SERVICE TECHNICAL INFORMATION

ONE POINT REPAIR

REF. NO. : SI-97-019
CUSTOMER RELATION SERVICE DIV.

MODELS : Z-M2800/M2900/VM280/VM290, NSX-F9/V800/V900
SUBJECT : No power/Sound Distortion due to power IC defect.
CONTENTS : Due to power IC(STK-419-***), defect, it is caused to no power or sound distortion. It requires to modify following contents to all repair items when replace in the above mentioned power IC.

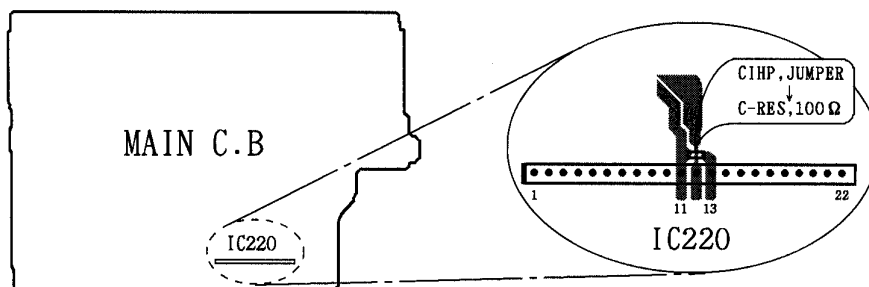
MEMO : This modification is required to do all in the above mentioned models for repair even power IC is not damaged.

REMEDY : To replace parts from chip jumper to chip resistor, $100\Omega \cdot 1/8W$, between pin ① and ⑬ of IC220.

Ref.	PARTS CODE	PARTS NAME
	88-128-101-010	C-RES, 100Ω 1/8W
